TSI-05-13-01

**Subject:** Minimal Lever Engagement or Jump Out on Eaton 8LL or 9LL Transmissions

## Service Bulletin: TMIB-0148

**Topic:** Minimal Lever Engagement on LL Models

**Figure 1a**

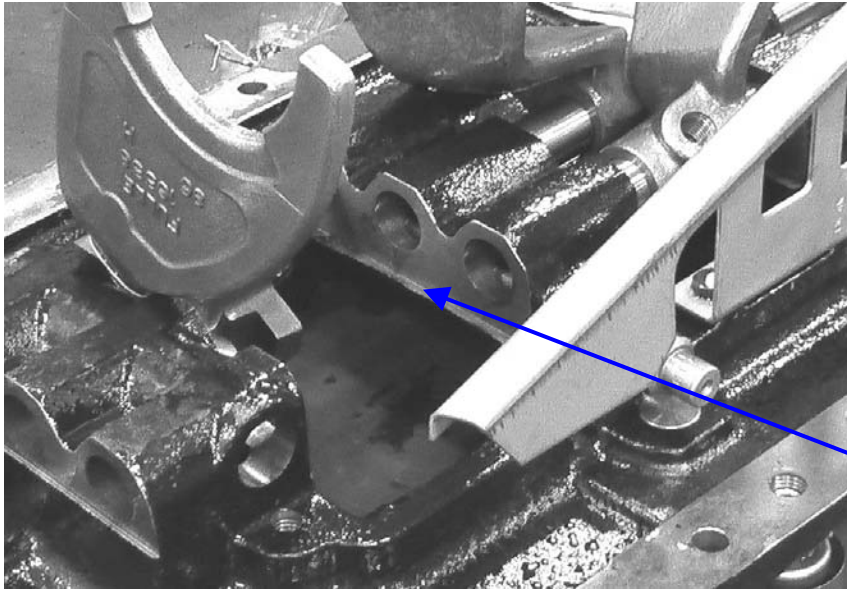
Some customers with 8LL or 9LL transmissions may experience a complaint of minimal lever engagement or lever jump out in the rearward lever positions. This condition is caused by an improper machining operation at the shift bar housing resulting in casting interference with the shift blocks.

If any of the above symptoms are present the shift bar housing should be removed from the transmission to inspect for this condition. The shift bar housing must be placed upside down on a bench for inspection (see figures 1a and 1b). If this condition is present the repair instructions below must be followed.

Area of Machining  
Defect

Step 1. Completely disassemble the shift bar housing

Step 2. Use a small grinder to remove the excess casting material until the surface is free of raised material. (see figure 2)

Step 3. Thoroughly clean the shift bar housing to eliminate any contamination from the grinding operation

Step 4. Reassemble the shift bar housing and install on the transmission
